# Access Compliance Report

## Public Rights-of-Way

### (Curb Ramps)

Intersection ID: 11262	Main Street: EASTWAY_DR	Cross Street: SHAMROCK_DR	Location: SE
ADA ID: 48F3DAC2BAFE	Ramp Type: IslandPerp	Initial Pass/Fail: Fail	Overall Compliance: No
Severity Score: 26.25			
Codes/Mitigation Info/Possible Solution		Field Measurements/Component Compliance

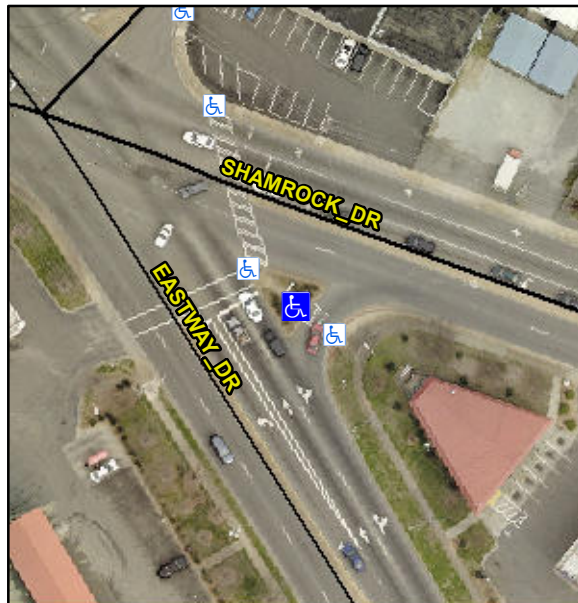
**Not Found, R304.2.2, R304.5.3**

Compliance	Description	Data	Compliance	Description	Data
N/A	Ramp Length (in)	67.5	No	Ramp Slope (%)	12.5
Yes	Ramp Width (in)	48.0	No	Ramp XSlope (%)	2.7
N/A	Flare Type LT	N/A	N/A	Flare Type RT	N/A
N/A	Flare Slope LT (%)	N/A	N/A	Flare Slope RT (%)	N/A
N/A	Flare Traversable LT?	N/A	N/A	Flare Traversable RT?	N/A
N/A	Landing Length (in)	N/A	N/A	DWS Provided?	N/A
N/A	Landing Width (in)	N/A	N/A	DWS Contrast?	N/A
N/A	Landing Slope (%)	N/A	N/A	DWS Length (in)	N/A
N/A	Landing X Slope (%)	N/A	N/A	DWS Full Width?	N/A
N/A	Landing Curb? (Y/N)	N/A	N/A	DWS Offset (in)	N/A
N/A	Shared Landing?	N/A			
N/A	Gutter Ponding?	N/A	N/A	Gutter Slope (%)	N/A
N/A	Gutter Lip Ht (in)	N/A	N/A	Gutter X Slope (%)	N/A
N/A	Painted X Walk1?	Yes	N/A	Painted X Walk2?	N/A
	X Walk 1 Direction	To SE		X Walk 2 Direction	N/A
N/A	X Walk 1 Width (in)	111.5	N/A	X Walk 2 Width (in)	N/A
	X Walk 1 Slope (%)	4.9		X Walk 2 Slope (%)	N/A
	X Walk 1 X Slope (%)	3.9		X Walk 2 X Slope (%)	N/A

**Remove & Replace Entire Ramp.**
